23 May 2014

Edition 10

AUSTRALIAN NOTICES TO MARINERS

Notices 476 - 518

Block for Aus 246 ©Commonwealth of Australia 2014 (72.5 x 83.5mm)

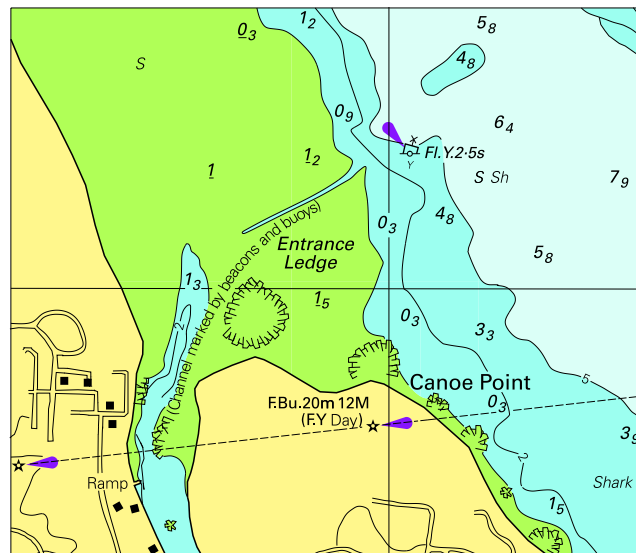
478* AUSTRALIA - QUEENSLAND - Boyne River - Nav aids

Insert	accompanying block	23° 56'.0 S	151° 21'.5 E
--------	--------------------	-------------	--------------

To accompany Australian Notice to Mariners 486/2014

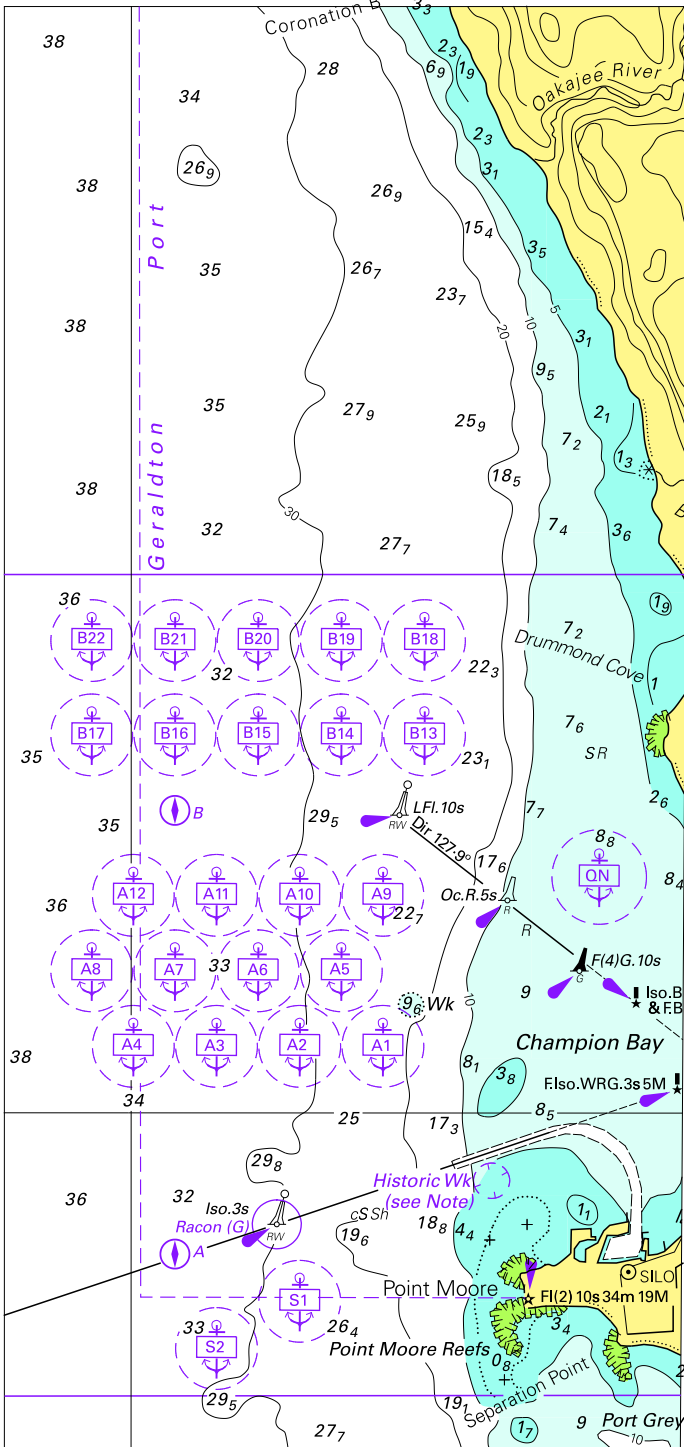
486* AUSTRALIA - NORTHERN TERRITORY - Darwin - East Arm - Infrastructure, dredged channel, nav aids

Insert	accompanying block	12° 29'.6 S	130° 53'.2 E
--------	--------------------	-------------	--------------

Block for chart Aus 751

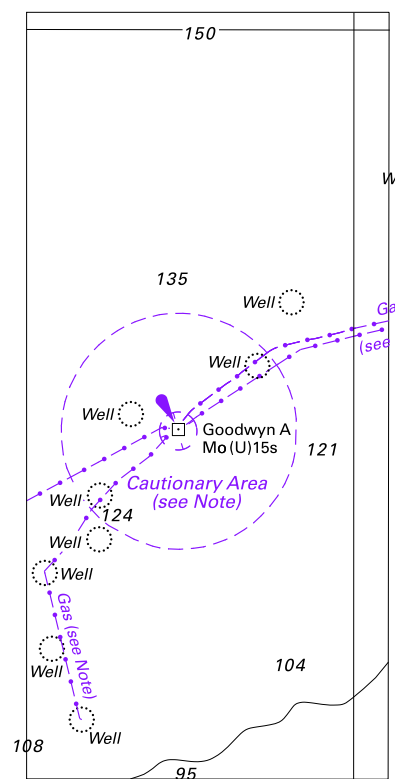
489* AUSTRALIA - WESTERN AUSTRALIA - Geraldton - Anchorages

Insert	accompanying block	28° 43'.0 S	114° 32'.0 E
--------	--------------------	-------------	--------------

© Commonwealth of Australia 2014
Block for chart Aus 327 (47.9 x 101.4mm)

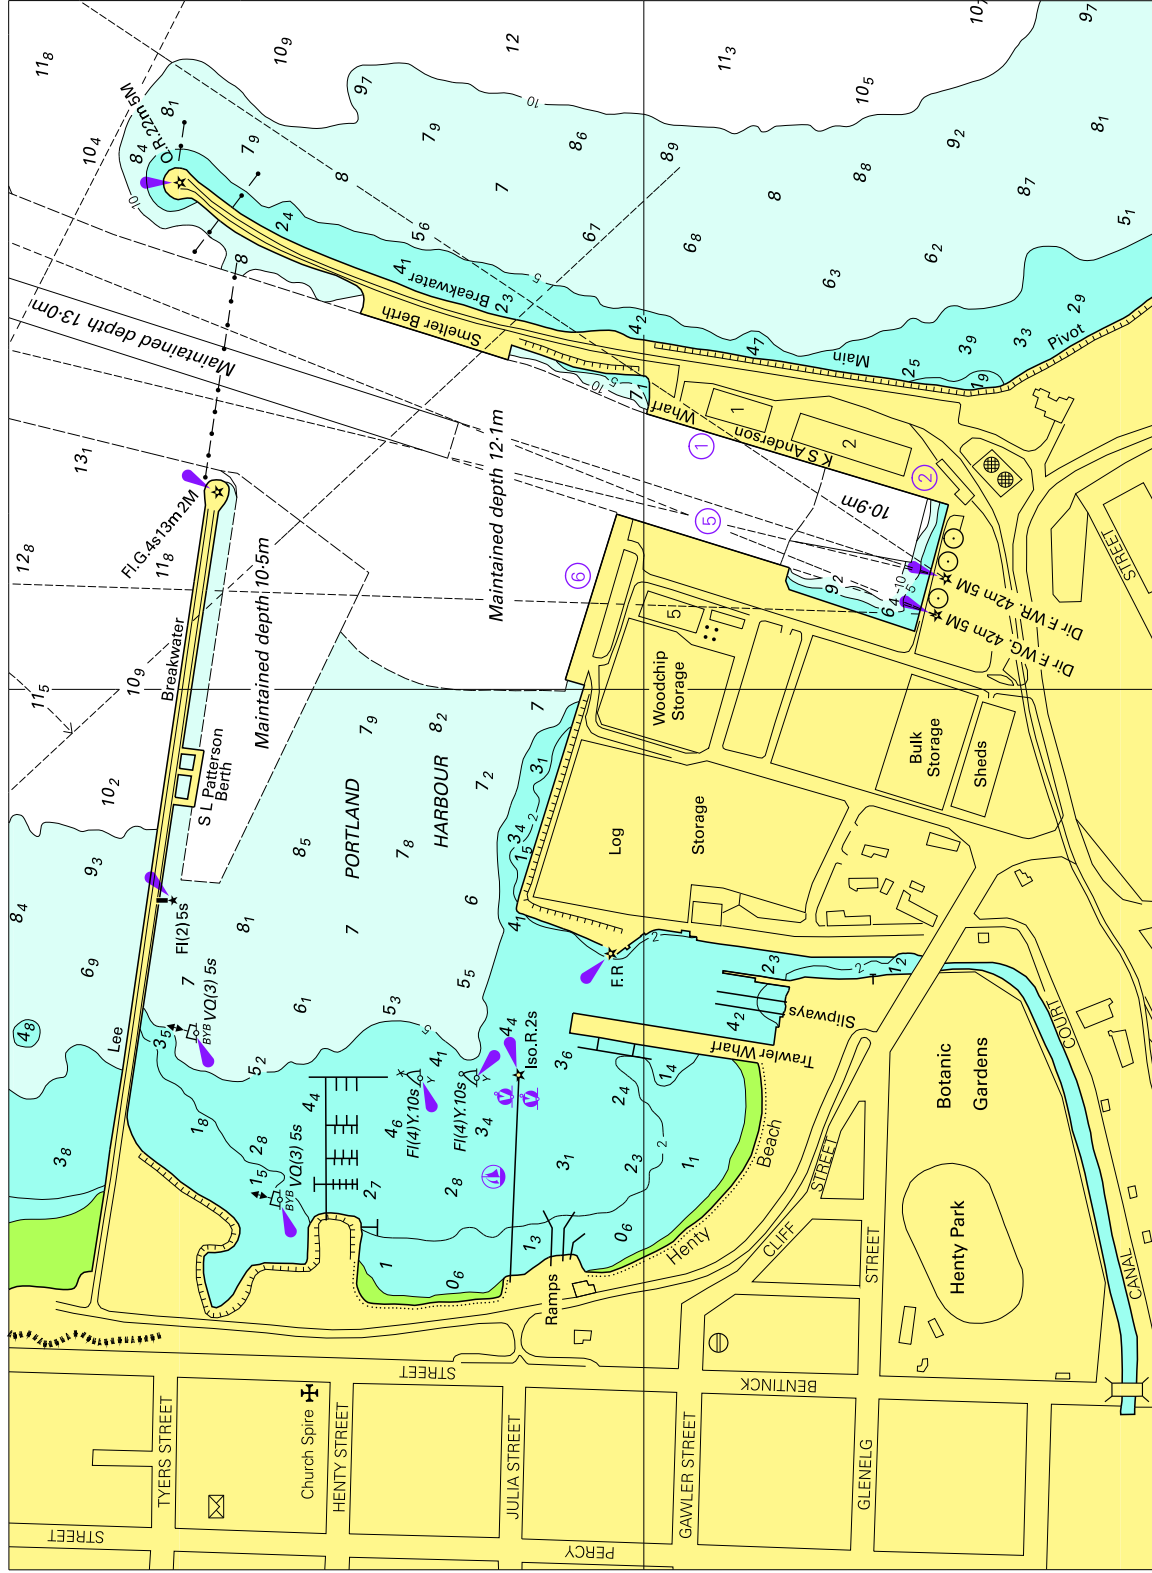
491* AUSTRALIA - WESTERN AUSTRALIA - Rankin Bank - Pipeline eastwards

Insert	accompanying block	19° 38'.0 S	115° 57'.0 E
--------	--------------------	-------------	--------------

© Commonwealth of Australia 2014
 Block for chart Aus152 (58.7 x 56.0mm)

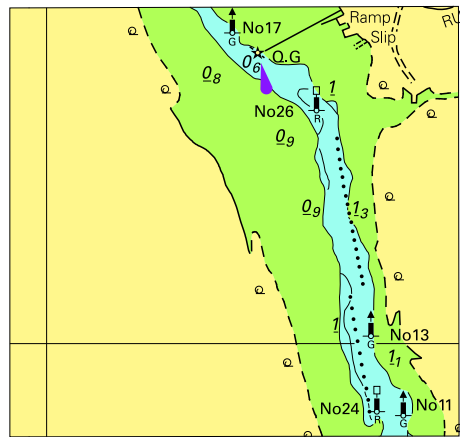
495* AUSTRALIA - VICTORIA - Western Port - Rutherford Inlet - Nav aids
Former Notice - 1072(P)/2013 is cancelled
Victorian Notice 90/2014 (AA739493), Parks Victoria (AA739644)

Insert	accompanying block	38° 13'.9 S	145° 18'.3 E
--------	--------------------	-------------	--------------
